INDIANA DEPARTMENT OF TRANSPORTATION

APPROVED MINUTES

November 19, 2025, Standards Committee Meeting

RE: Minutes from the November 19 Standards Committee Meeting

E 715-PHCL-01 PIPE HEIGHT OF COVER LIMITS (with markups)

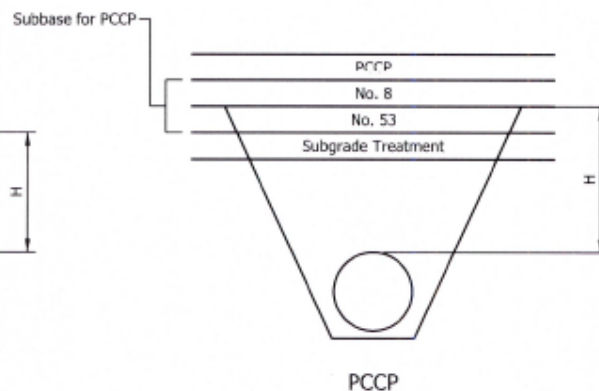
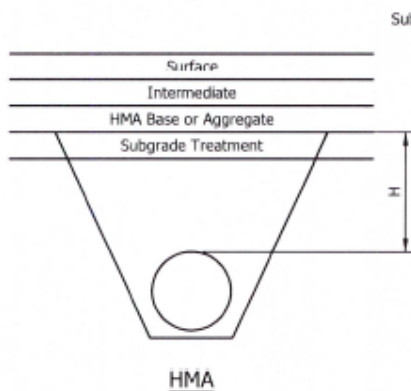
Mr. Reilman proposed to delete the pipe material types that do not have any suppliers listed on the qualified products list, and incorporate the proposed changes shown to clarify pipe material types acceptable for specified applications, add a reference to require ASTM C913 for inlets and catch basins, edit and clarify the manufacturer requirements in the table in 907.16, cascade these edits to the applicable sections following 907.16, and update the liner pipe sections.

Mr. Koch asked if by eliminating some types of plastic pipe, would we also be eliminating a potential source of future materials? Mr. Reilman responded: Not likely. If a company decides to change or adjust operations to make a pipe that they previously did not make, they can always follow our procedure for getting on a QPL. The five pipe types where I am deleting the QPL option, it is impossible for them to get on our QPL because they cannot get an AASHTO audit; AASHTO doesn't audit these pipe materials. In the future if AASHTO decided to add one or more of these into their Thermoplastic Pipe program, then INDOT can revise our specification at that time.

| 2026 Standard Specifications Sections: 715, pg(s) 744 - 748. 904, pg(s) 1042 - 1051. Recurring Special Provisions or Plan Details: NONE Standard Drawing affected: E 715-PHCL E 715-PIPE Design Manual Chapter: NONE GIFE Section: 4.11.2 | <input checked="" type="checkbox"/> 2028 Standard Specifications <input type="checkbox"/> Revise Pay Items List <input type="checkbox"/> Notification to Designers if change is <u>not</u> addressed by RSP <input checked="" type="checkbox"/> Create RSP (No. <u>715-R-809</u>) Effective: <u>June 1, 2026</u> <input type="checkbox"/> Revise RSP (No. <u> </u>) Effective: <input checked="" type="checkbox"/> Standard Drawing (E 715-PHCL and E 715-PIPE) Effective: <u>September 1, 2026</u> <input checked="" type="checkbox"/> Create RPD(s) (No. <u>715-R-810d</u> and <u>715-R-811d</u>) Effective: <u>June 1, 2026</u> <input checked="" type="checkbox"/> GIFE Update <input checked="" type="checkbox"/> Frequency Manual Update <input checked="" type="checkbox"/> AWP Update |

STANDARD DRAWING NO. E 715-PHCL-01

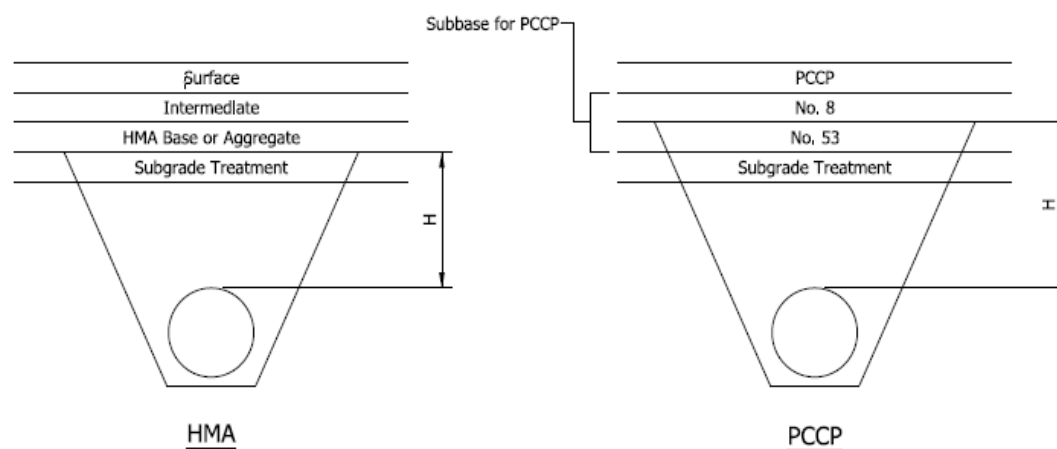
1. The tabulated cover depth H shall be measured from the top of the pipe to the bottom of the drainage No. 8 layer for PCCP and from the top of the pipe to the top of the subgrade treatment for HMA pavement.
